ILMAILUHALLITUKSEN TIEDOTUKSIA
INFORMATION FROM THE NATIONAL BOARD OF AVIATION**MUUTOSMÄÄRÄYS**
AIRWORTHINESS
DIRECTIVE

M 1119/82

1119. Jantar. Mittaritaulun suojuksen kiinnitys

Bulletin No. BK-015/81 "Jantar"

Fig.1.

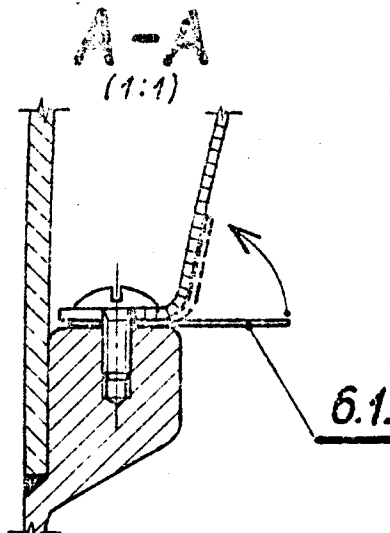
- Irrota mittaritaulu.
- Irrota mittaritaulun suojuksen kiinnitysruuvit.
- Kiinnitä ruuvit takaisin varustettuina kuvan 1 mukaisilla varmistuslevyillä. Asennusohje on kuvassa 2.
- Sen jälkeen, kun ruuvit on kiristetty, niin taivuta levyt (no. 6.1) kuvan 2 mukaisesti.

Blaszka zabezpieczająca (6.1).
Protected plate (6.1)
(1:1)

material : M63-r (≠Q5×15×30)
ilość : 2 szt./kpl.
quantity : 2 pcs./set.

Fig.1.

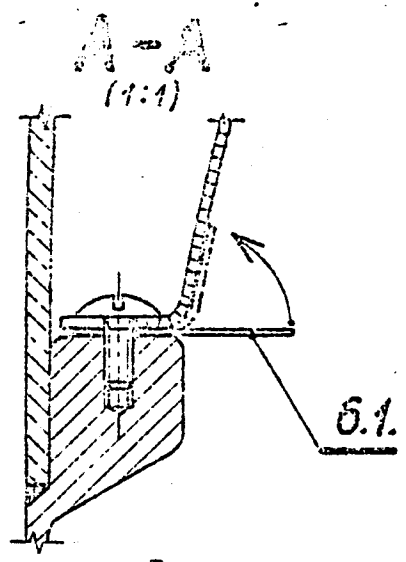
Change in the way of the panel cover securing against shifting out, consist in use the plate/Fig.1/. This plate after fixing as on sketch Fig.2, bend to cover making impossible unintentional shifting out of the cover from the heads of fixing screws.

In case of repeated removing of cover the plates should be bent back /the plate material allows for repeated bending/. If the plates is failed the new one should be prepared acc. to Fig.1.

Blaszka zabezpieczająca (6.1).
Protected plate (6.1)
(1:1)

material : M63-p (≠05x15x30)
 ilość : 2 szt./kpl.
 quantity : 2 pcs./set.

Fig.2.

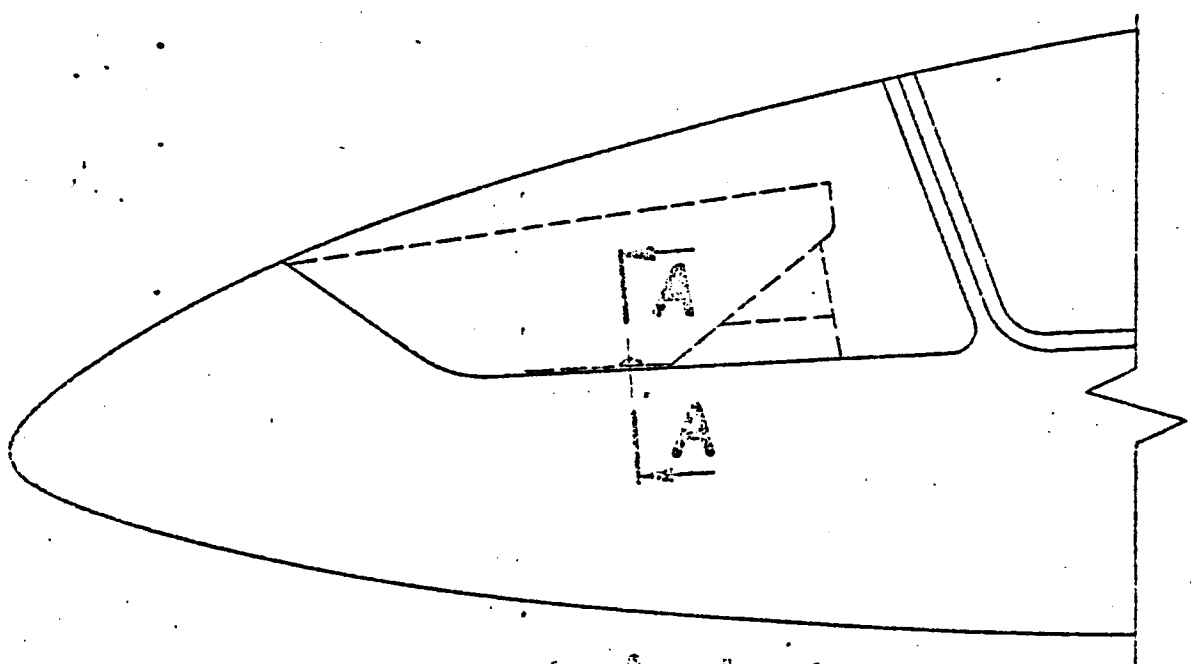
When the instrument Panel is removed, screw off the cover fixing screws and then put on it the securing plates /6,1/. Next screw on the screws on position hollowing the gap for tight fitting of cover edges.

When the cover is fitted, bend up the plates on the way shown on Fig.2.
